Proposed Anaerobic Digestion Plant at Red Linhay in Halberton, Tiverton

Technical Report

On behalf of **Mid Devon District Council**

Project Ref: 38071| Rev: A – Final Issue to MDDC | Date: May 2016

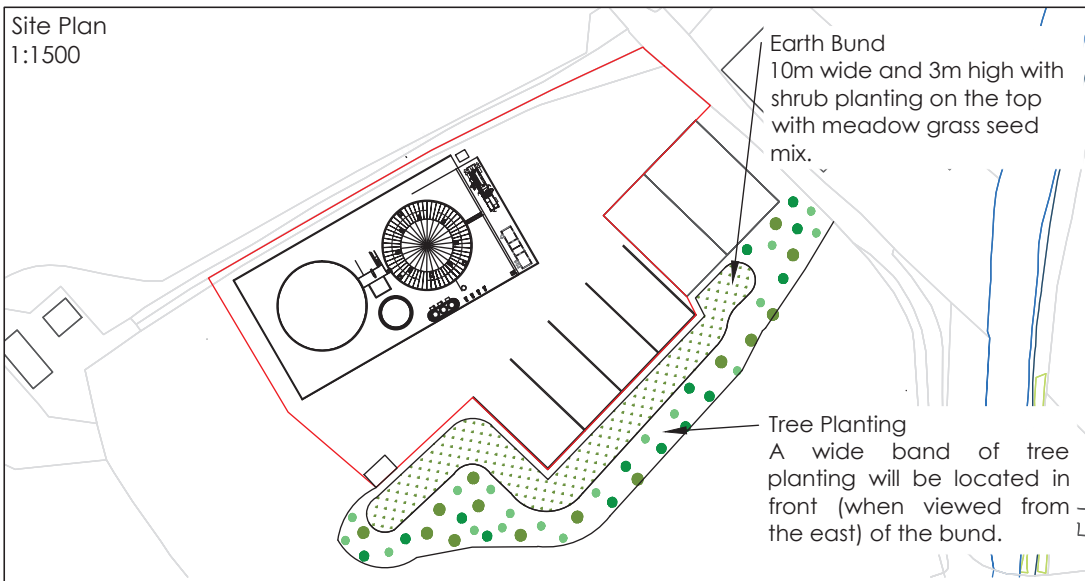
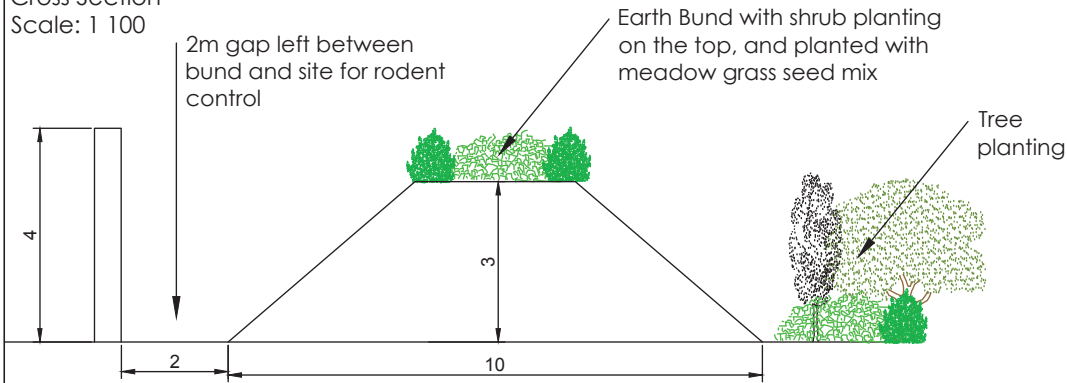
- 2.2.4 With the consented scheme, the bund associated with the scheme is not mentioned in the LVIA, and may have been added after the LVIA was undertaken. Drawing WIN01_Redlinhay_PP_05 (included in [Appendix A](#)) which shows the bund is dated June 2014 whereas the LVIA is dated September 2013. This is of importance as given its gradient of what appears to be 1:1, it is clearly out of character with the gentle slopes of the site and its context. However, paragraphs 49 to 52 do not mention any effects on landform.

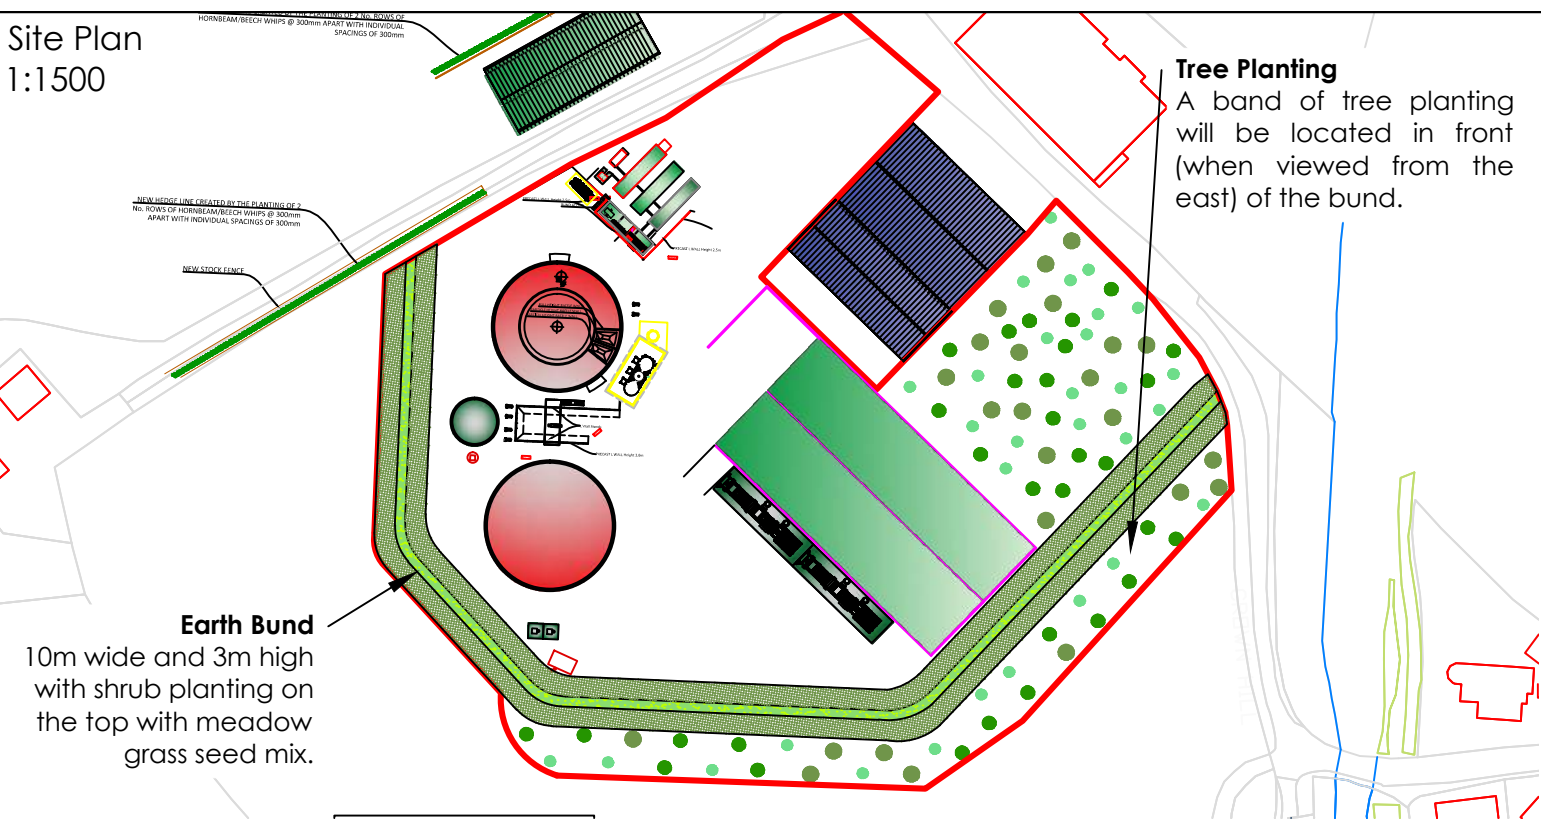
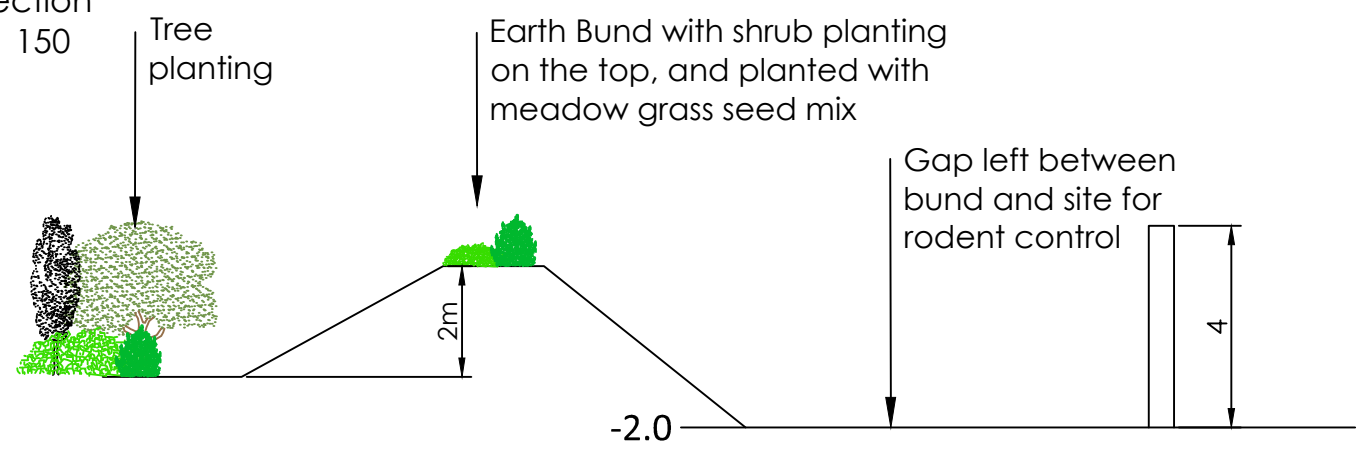
- 2.3.1 The landscape proposals for the application show bunding that is much more extensive than that of the consented scheme. No gradients are shown for the bunding but the drawing shows it as steep and out of character with the landscape in which it is located, where the slopes are gentle, as was the case with the consented scheme. However, given that the extended bunding, currently under construction, runs along the western boundary, it is clearly visible in the views from the canal where it is seen extending into the more open countryside. No planting is proposed on the steep slopes, and without gradients it is not clear if planting would be achievable.

- 2.4.3 As set out in the analysis of viewpoints above, the extension of the rather clumsy bunding is a significant difference between the two schemes, and has not been adequately covered in the LVIA. As the photographs provided show, it is a notable change to the proposal that is out of character with its setting.

- 2.5.9 Instead, an approach would be to seek to negotiate a modification to the bund so that it has a shallower outer slope, more akin to the adjacent landform than is currently proposed. Additionally, if there are problems with carrying out additional planting on the bund because of concerns about its integrity, then you should seek to agree additional planting along the toe of the bund.
- 2.5.10 The shade of green for the dome does not accord with the approved colour for the consented scheme, and is inappropriate because it is too bright. It also has a reflective surface which, combined with the shade of green, means that the dome is too prominent in local to medium distant views. The colour and the reflectiveness could be controlled through a condition.

Figure 3
 South Elevation Overlay
 Drawing Number - WIN01_Redlinhay2_EIOv106_001

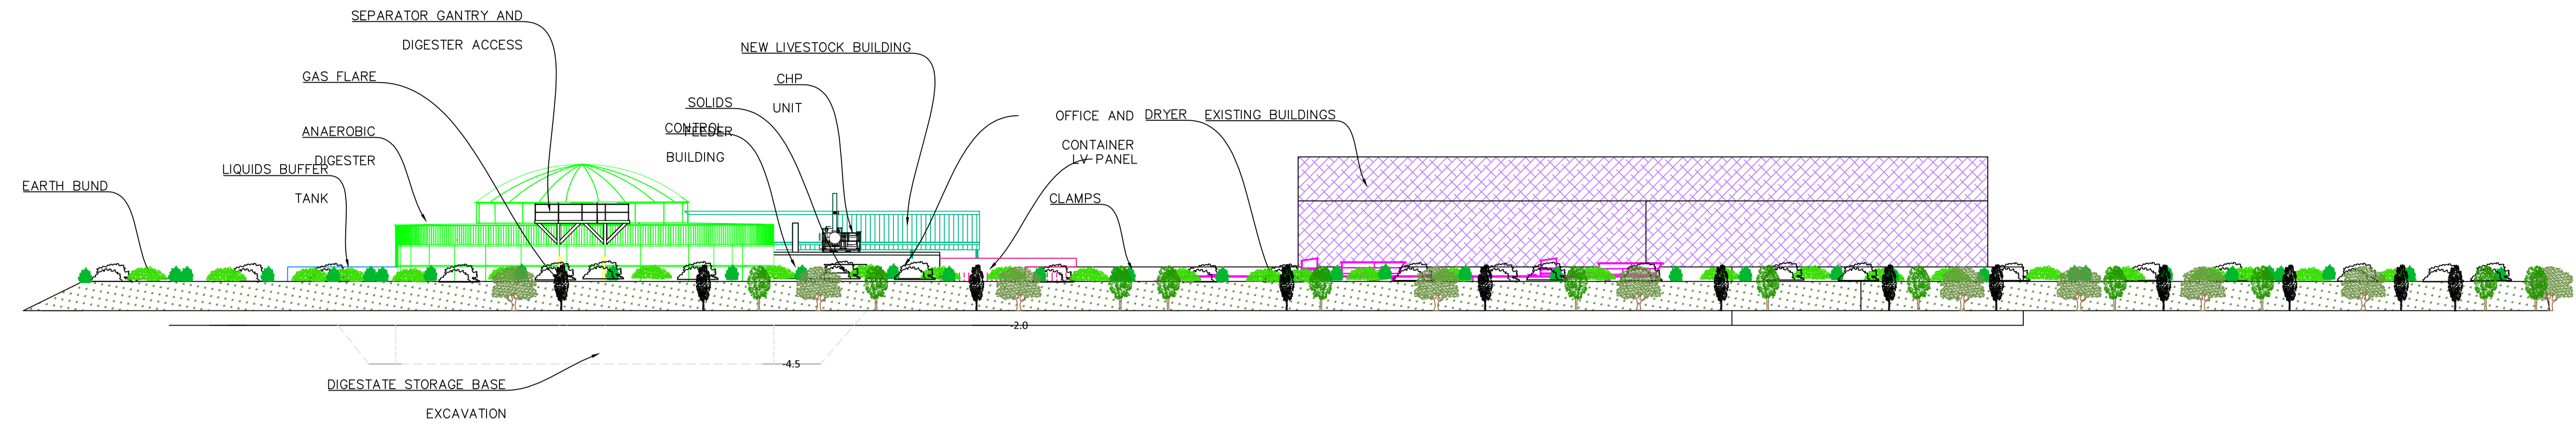
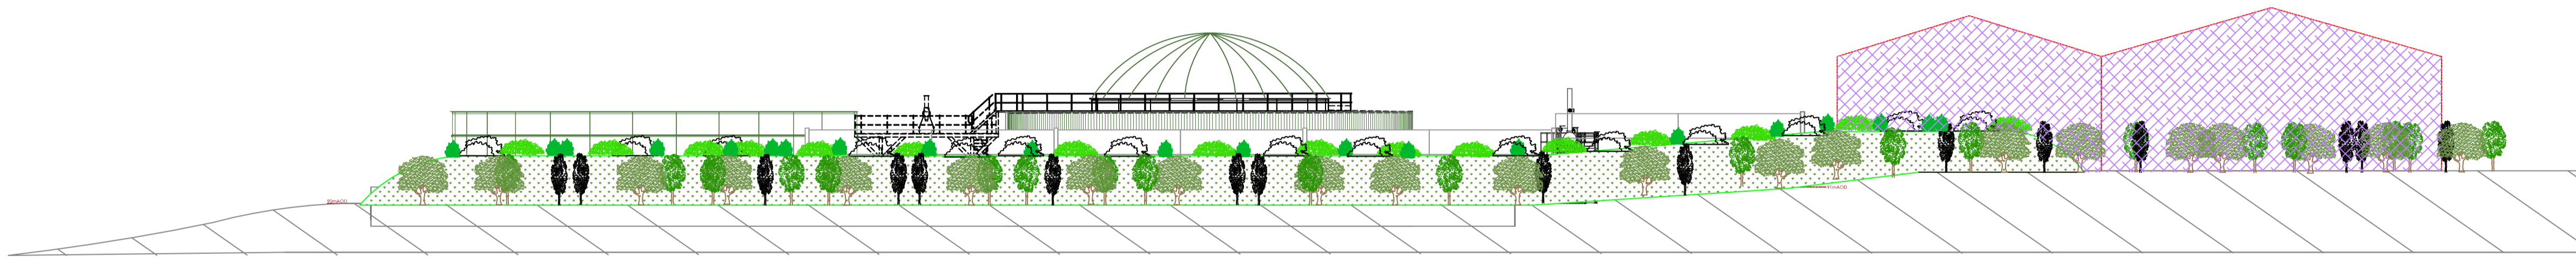
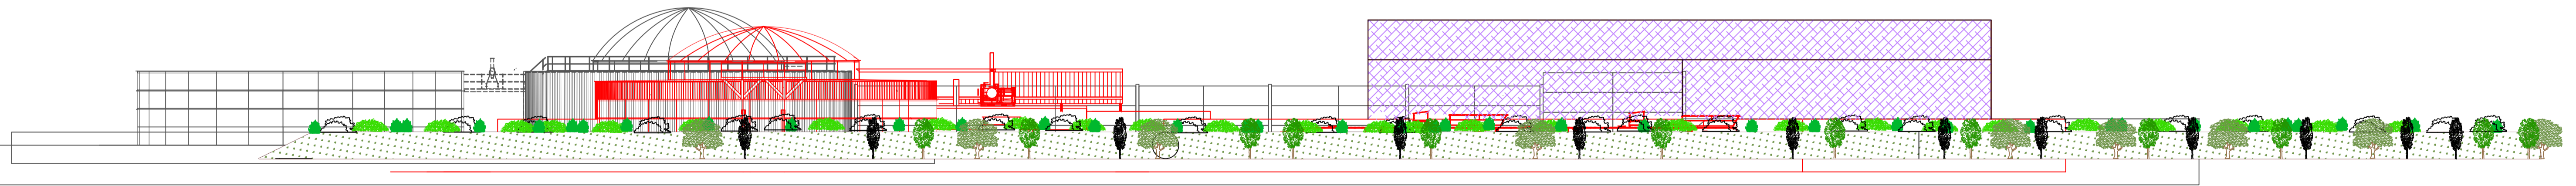
- 2.4.1 Given that a scheme has already been consented on the site and established the ability of the site to accommodate such development, one of the key issues is the difference between the two schemes. The applicant has produced a plan and elevations showing the two schemes overlaid to show the differences, and an overlaid plan has been produced for this review showing the bunds and landscape treatment for both schemes (see figure in [Appendix D](#)). In summary, setting aside the bunds, the scheme under construction has advantages over the consented scheme in that the dome appears slightly lower as a result of lowering of ground levels, and slightly nearer the other proposed structures. Additionally, many structures are much lower and although the site is more extensive, the effects are reduced as can be seen in the applicant's drawing E10v_001 (included in [Appendix E](#)) which is a comparison of the south elevation.

- 3.14.5 The elevation plans of the new proposal (see **Appendix G**) also show that the majority of the structures proposed under the previously approved plans will be closer to the existing agricultural buildings, and are therefore less likely to change the long-distance views into the site from the Conservation Area. This assumes that the form and colour of these structures does not differ substantially from the existing agricultural buildings.

Drawing No.	Revision
13425/T03	A

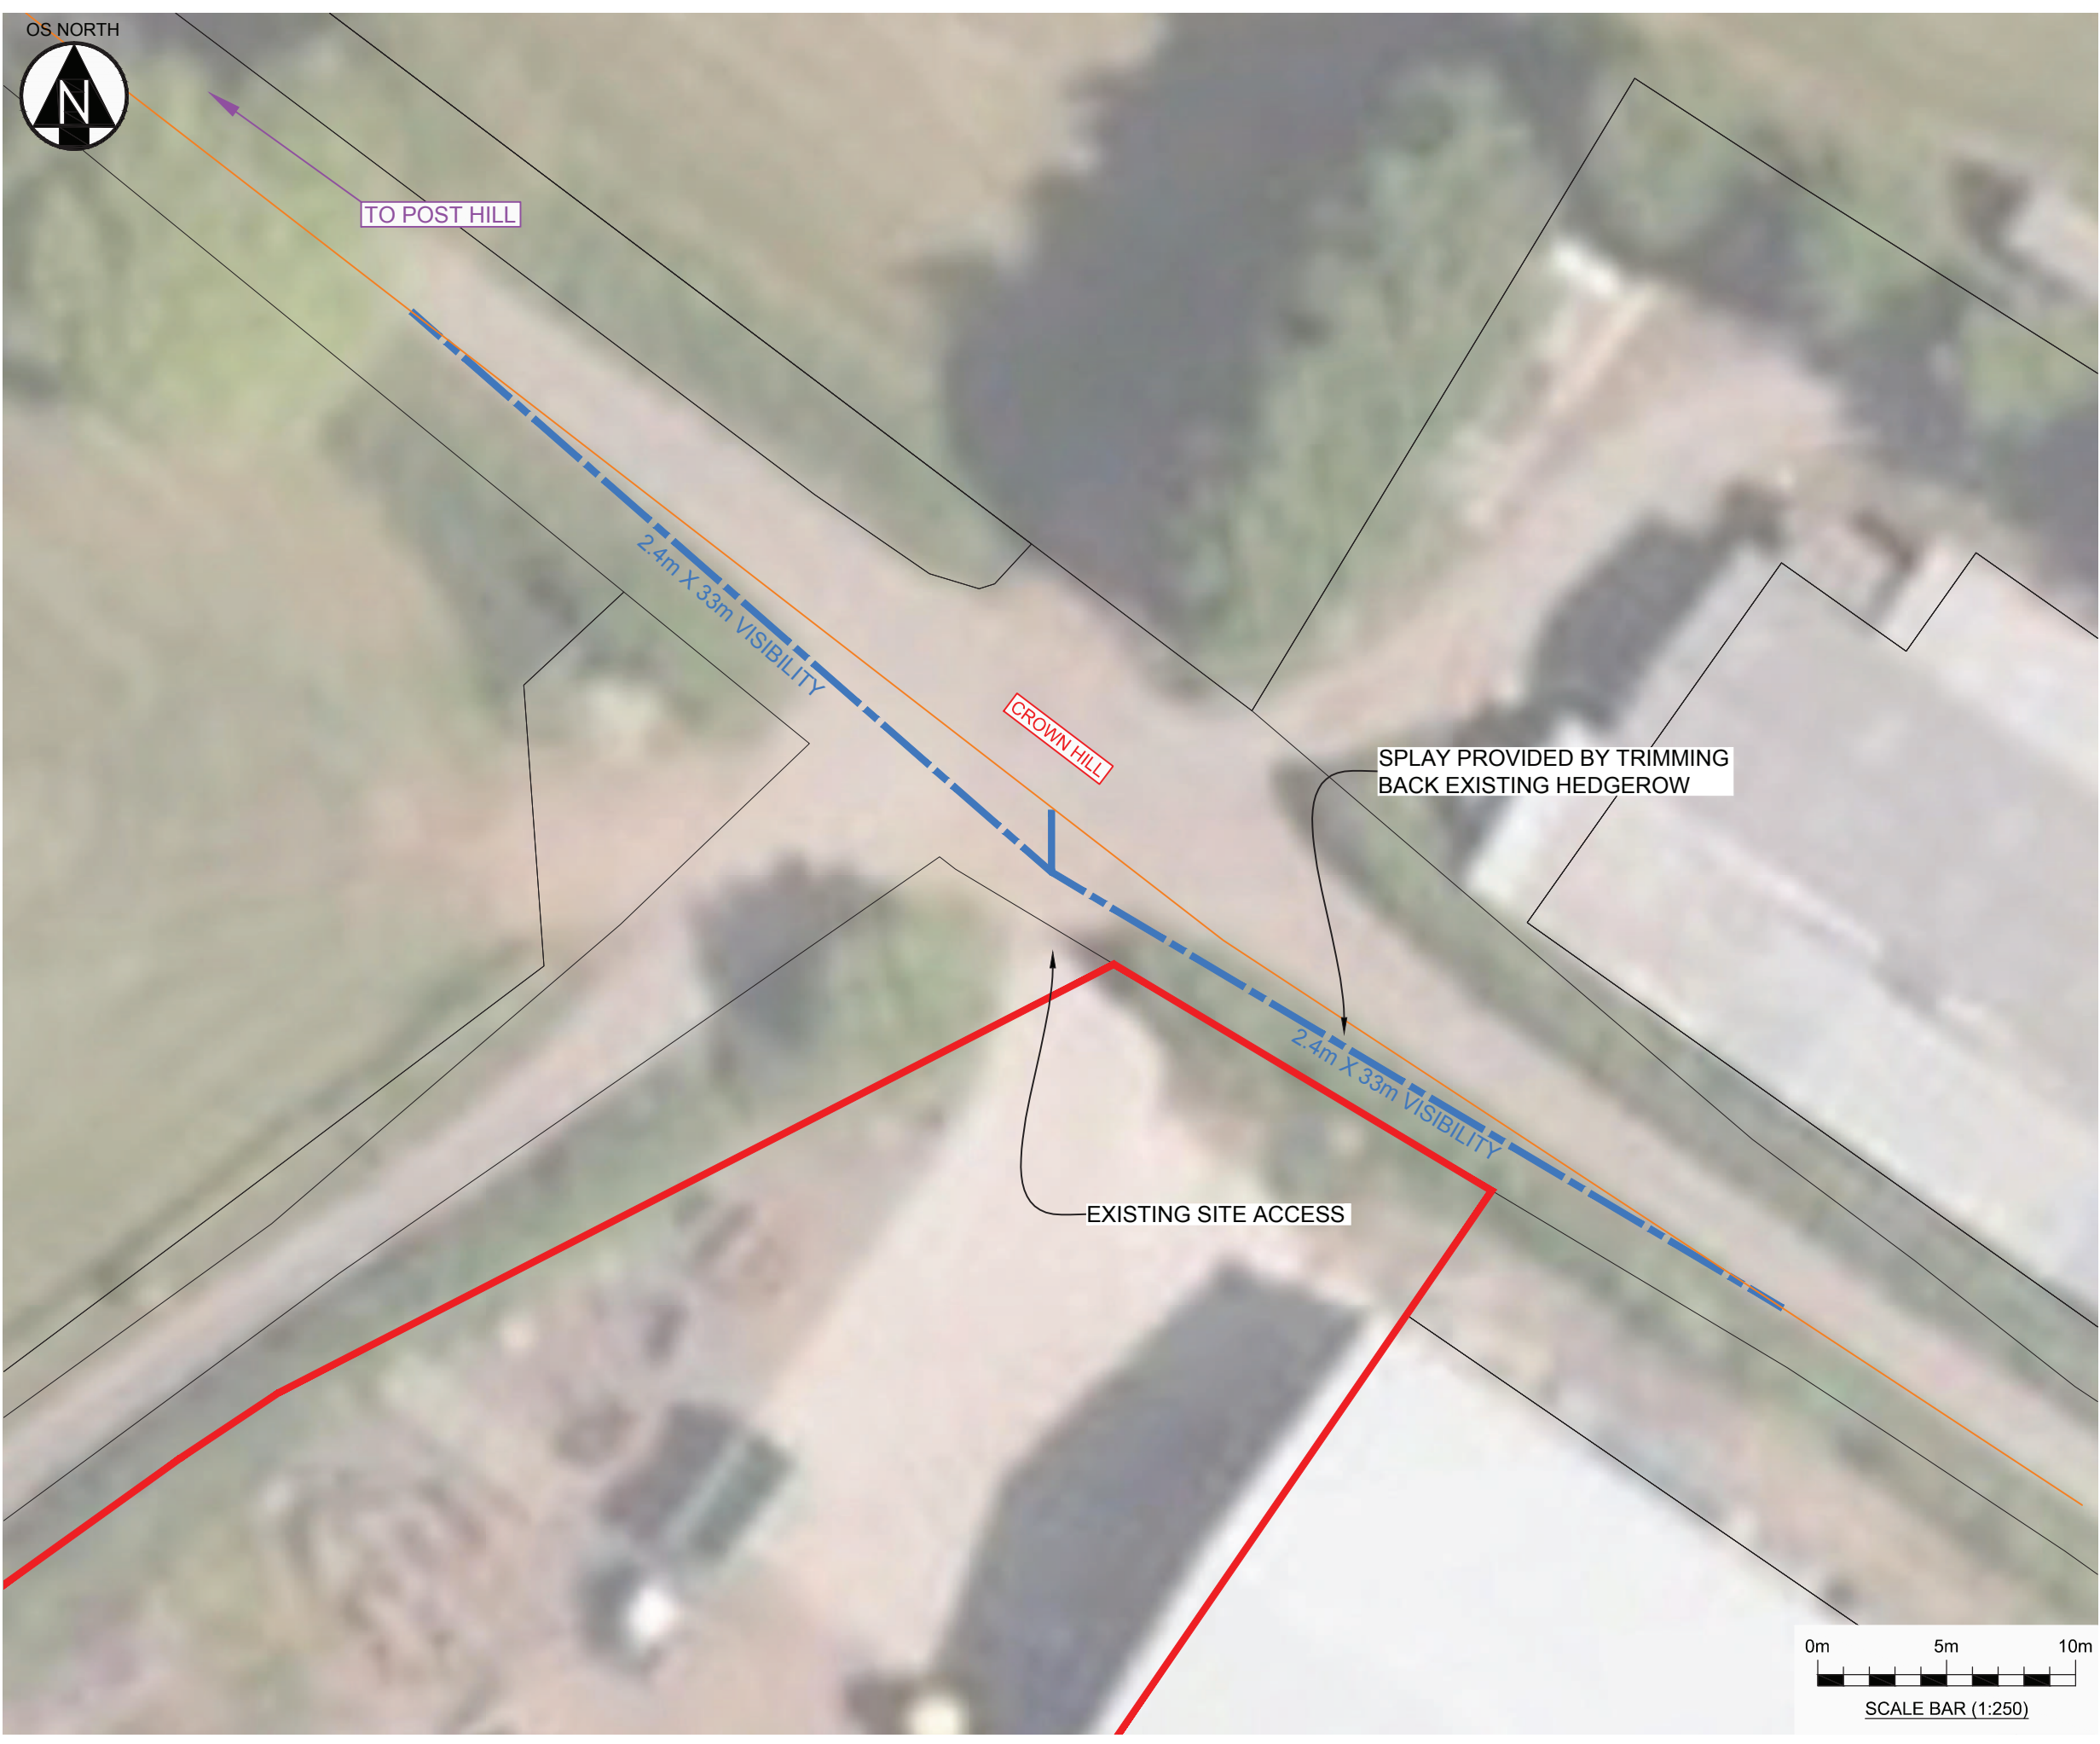
- 6.3.2 Drawing 13425/T03 included in the TS (and included in **Appendix I**) supporting the consented application suggests that the vegetation immediately to the east along the Crown Hill boundary will be cut back so that visibility splays from the minor arm in both directions meet 2.4m x 33m which is the recommended distance specified in the Manual for Streets guidance document.

- 6.3.4 It should be noted that the access currently provided at the site appears to have been more extensively modified than stated in the approved TS. The TS only refers to trimming back an existing hedgerow located immediately to the east of the access to improve visibility in this location, however on site observations suggest that vegetation to the west has been removed in order to create a significantly wider access. If our understanding of this issue is correct, it does not appear that the applicant is seeking for these modifications to the access to be approved under the current application.
